BIDDERS BULLETIN

PROJECT: Gateway Realty of North Platte
North Platte, Nebraska

BB-1

DATE ISSUED: February 7, 2014

DATE: February 6th, 2014
DRAWING: E101.1
FROM SHEET: E101

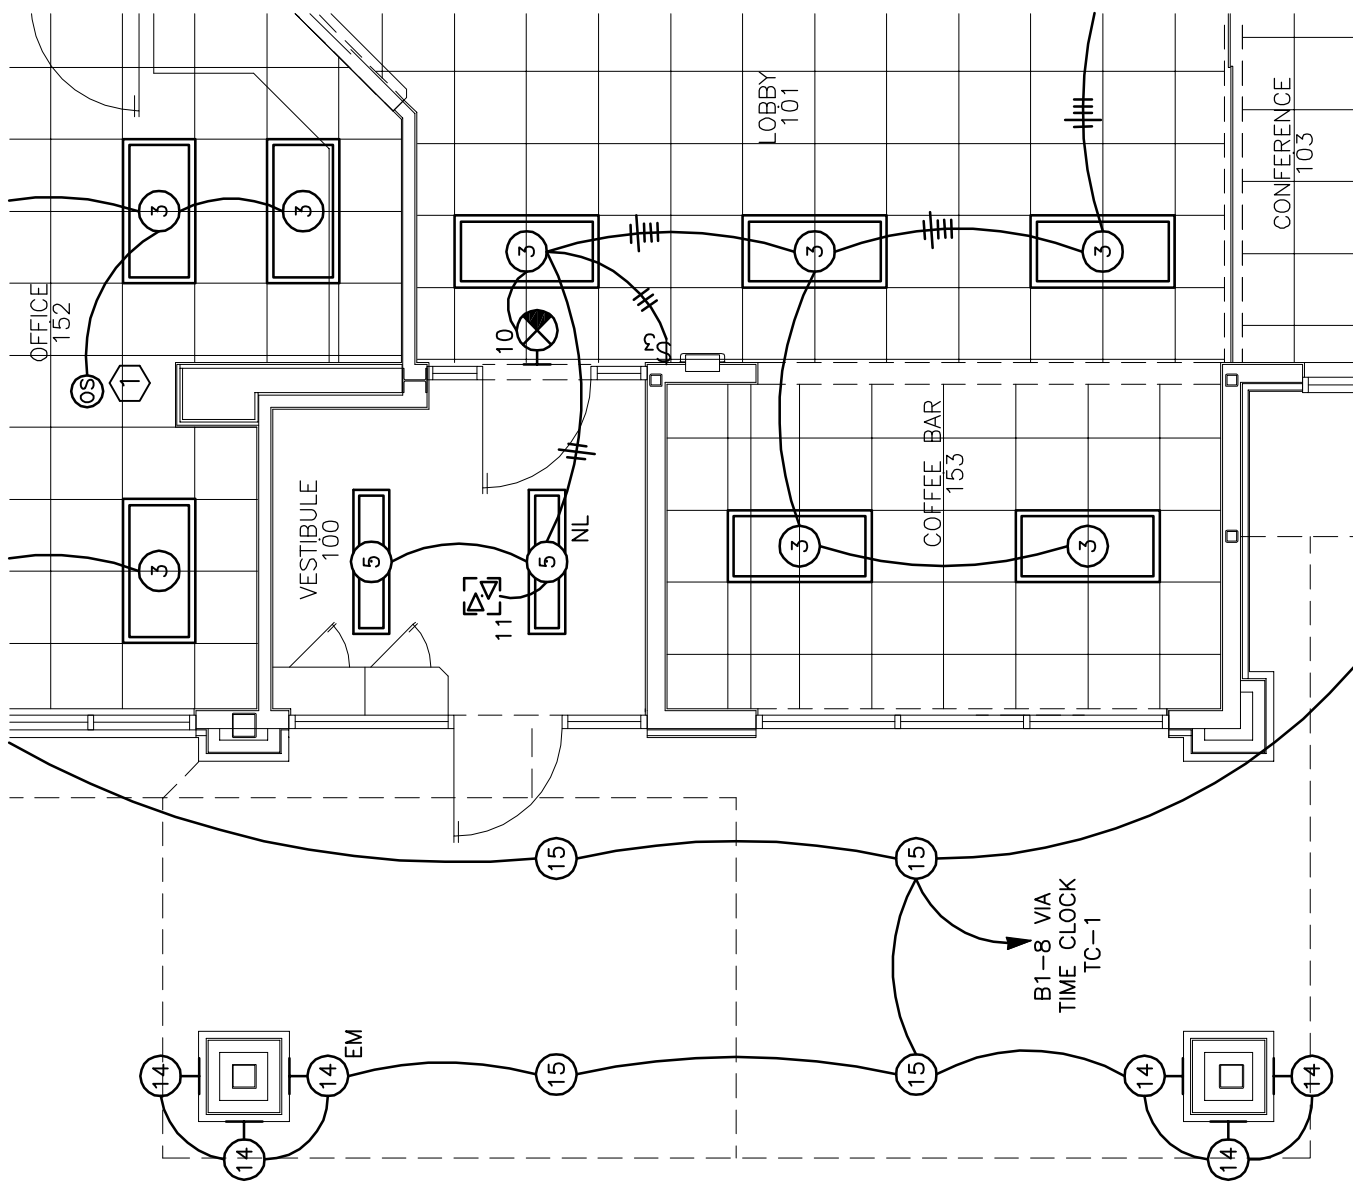
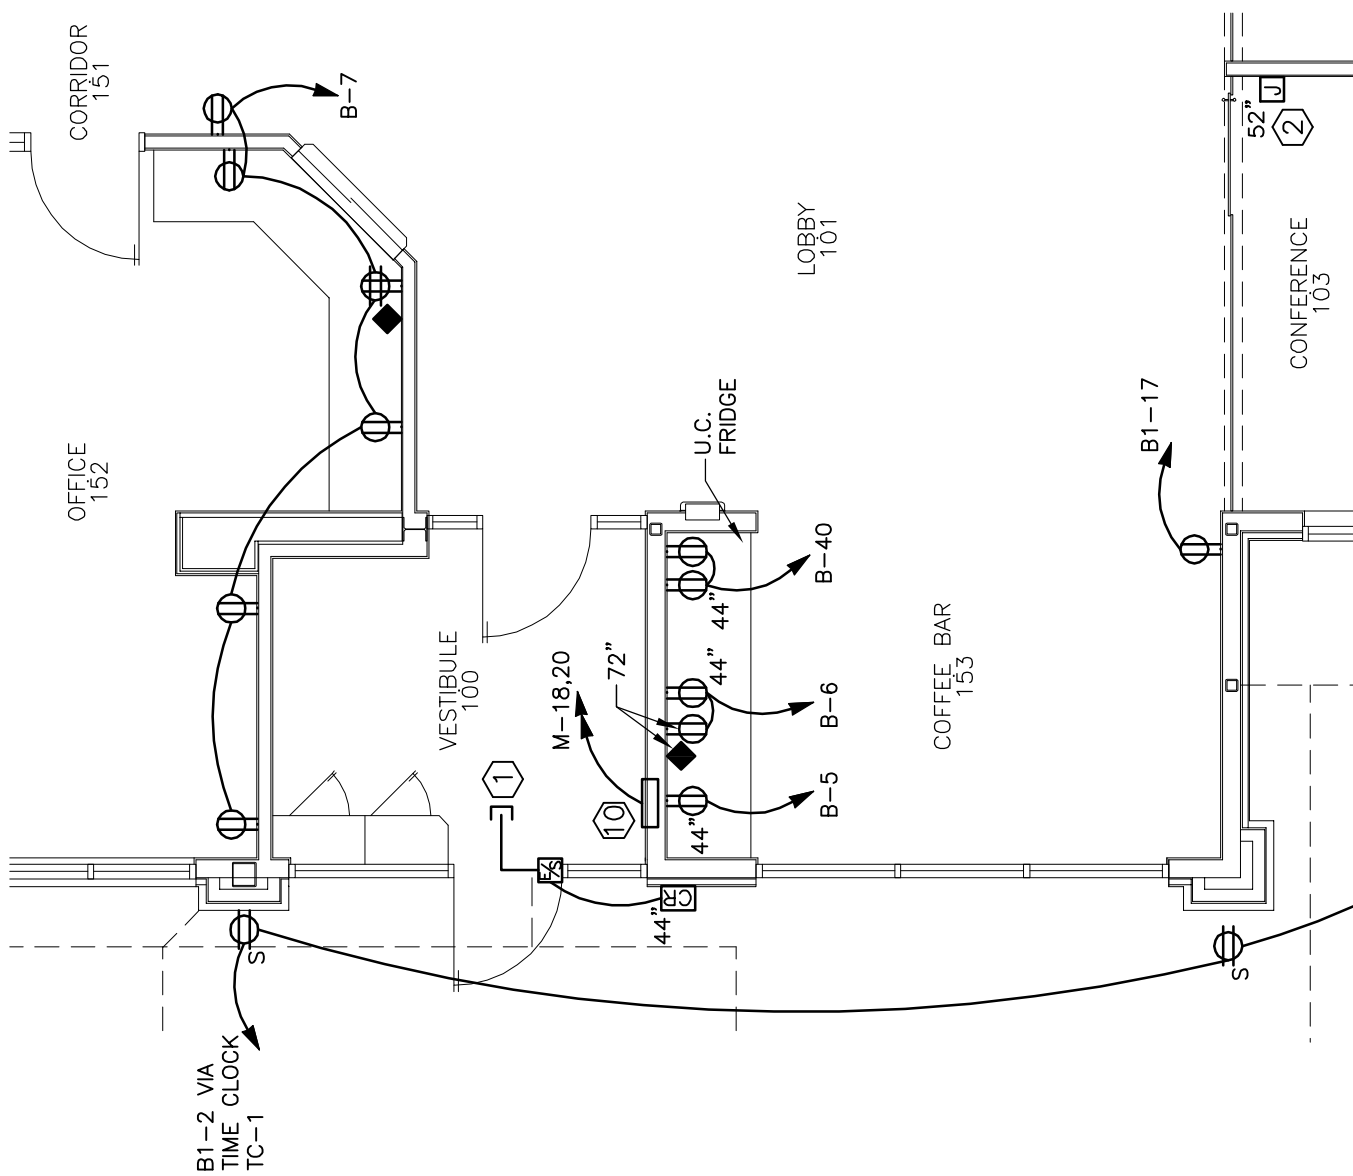
- Type #17 in the light fixture schedule is now specified. Please see attached drawing E-1R for more information.
- Refer to sheet E101.1 Revised Lighting Plan
 - Lighting plan modified to accommodate revised floor plan
 - Undercounter lights have been removed from Coffee Bar area.
 - Relocated switch serving lobby lighting
 - Emergency light for egress purposes on exterior column is now shown on the north column in lieu of the south due to new exit door location.

DATE: February 6th, 2014
DRAWING: E102.2
FROM SHEET: E102

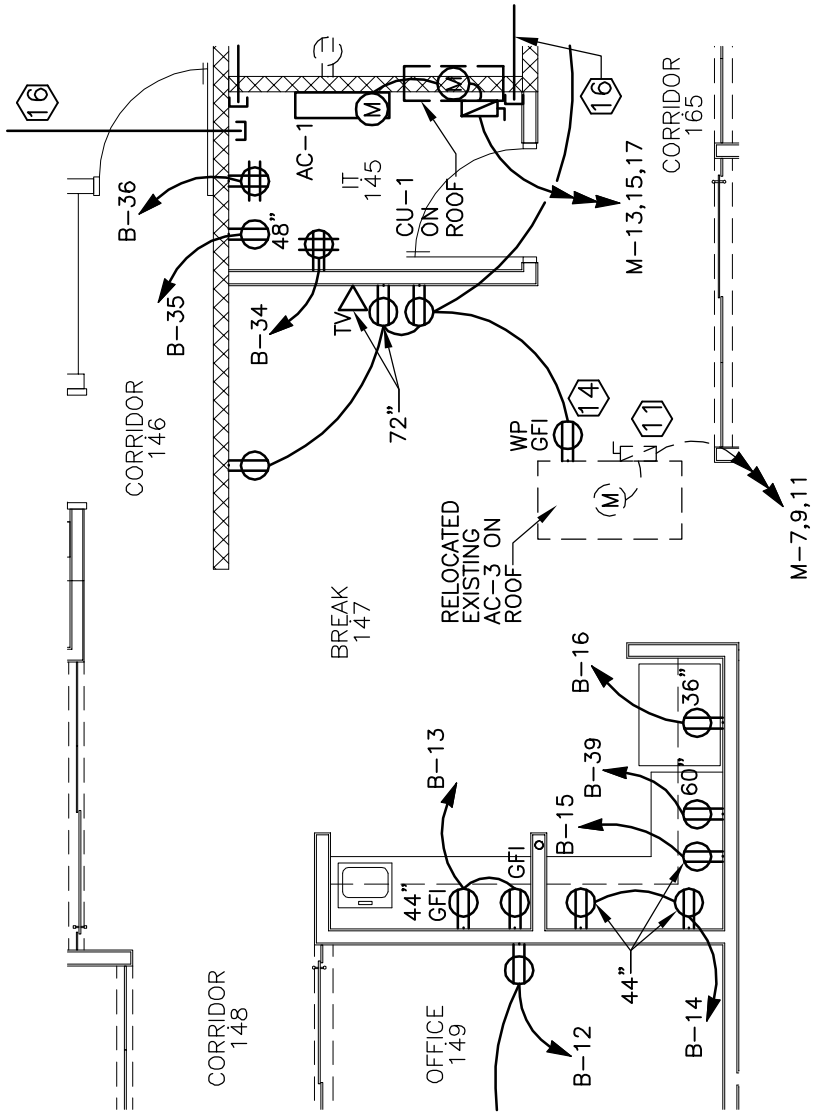
- The power layout in Work Room130 has been revised. Adjustable shelving is to be installed on the north and west walls of this room and the electrical has been removed in those areas. Please see new power layout on the attached sheet E-1R for more information.
- It is the responsibility of the Electrical Contractor to supply the (3) electrical hand dryers specified in section 10800.
- Refer to sheet E102.2 Revised Power Plan:
 - Additional receptacle and cable TV outlet have been added to the east wall in Break room 147.
 - Additional receptacle and 2-gang box at 72" A.F.F. per Power Plan Notes 2, 3 & 4. Center 3 & 4 on the north wall of Coffee Bar 153 above the coffee bar. Keep the (2) outlets at 44" A.F.F. as indicated on the original drawing.
